REMARKS

Applicant : Jan Andersson et al.
Serial No. : 10/673,689
Filed : September 29, 2003
Page : 13 of 13

Amendments to the Drawings:

Fig.13

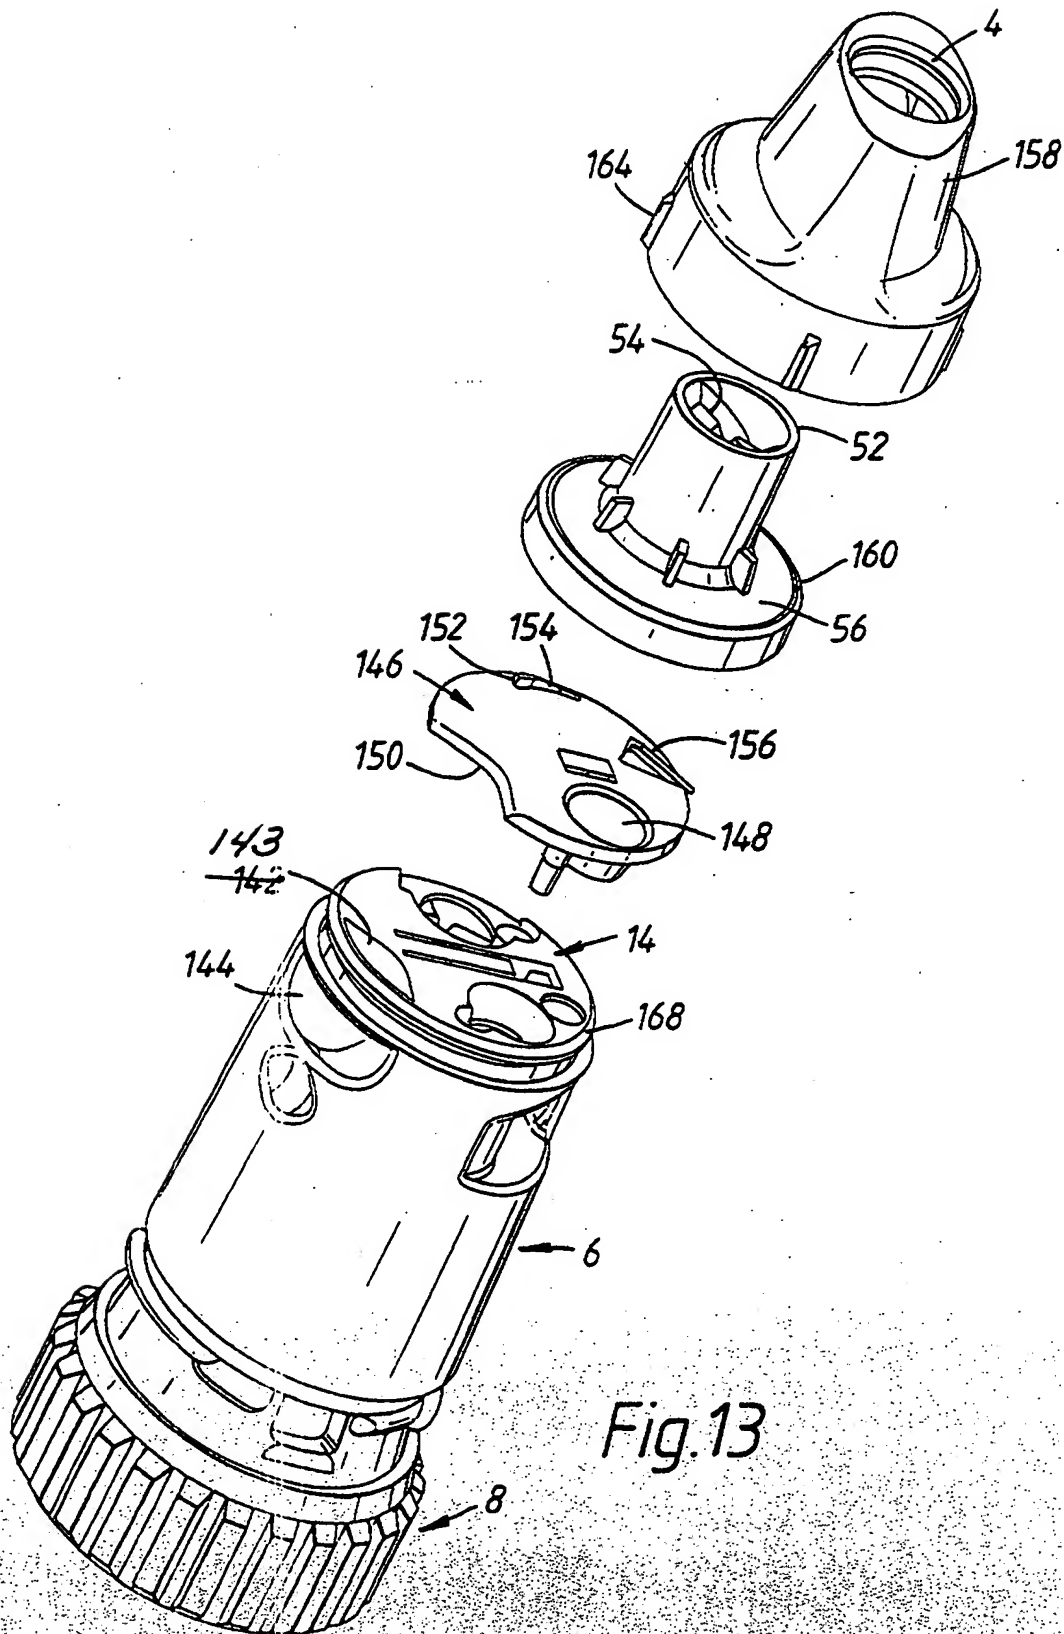
In Figure 13, reference number 142 which points to the supplementary air inlet has been changed to reference number 143. The specification has been amended to reflect this change.
